Note Listed building consent and planning application relates to apartments 1,2,3 and 4. Apartment 4 works (except replacement windows) was approved under listed building consent 3/2022/1159 dated 19 July 2023.

Drawing Title: PROPOSED FLOOR PLANS AND ELEVATIONS
 Project: Number 1-4, Almhouses, Stydd lane, Ribchester, PR3 3YQ
 Client: Your Housing Group
 Scales @ A1: 1:50
 Job Number / Dwg. No. / Revision: 3184_L_02_V01-A
 First Issue Date: 31/05/2024
 RIBA Stage: Drawing Status
 Drawn: BMC
 Check: GL
 [2] - PRELIMINARY

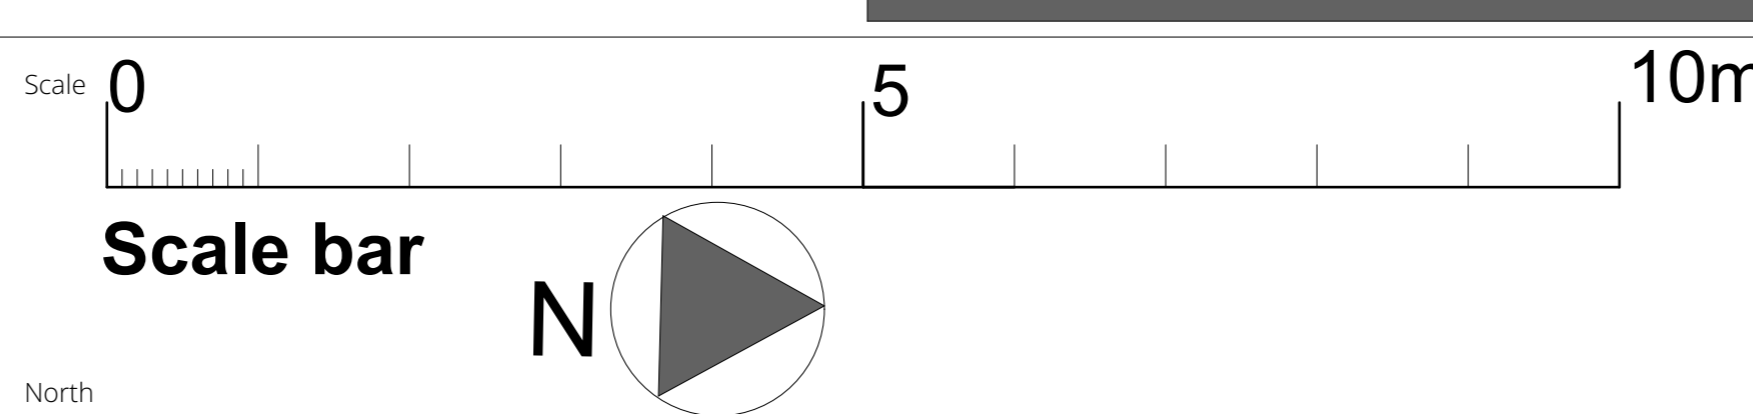
Scale	0	5	10m
Scale bar			
North			
<small>A (17/11/25) Arched heads removed from rear elevation windows, render repair replaced with render replace with lime render system at request of planning and conservation department (BMC)</small>			
Rev.	Date	Description	Drawn
This drawing is copyright of Halsall Lloyd Partnership & must not be reproduced unless specifically agreed in writing.
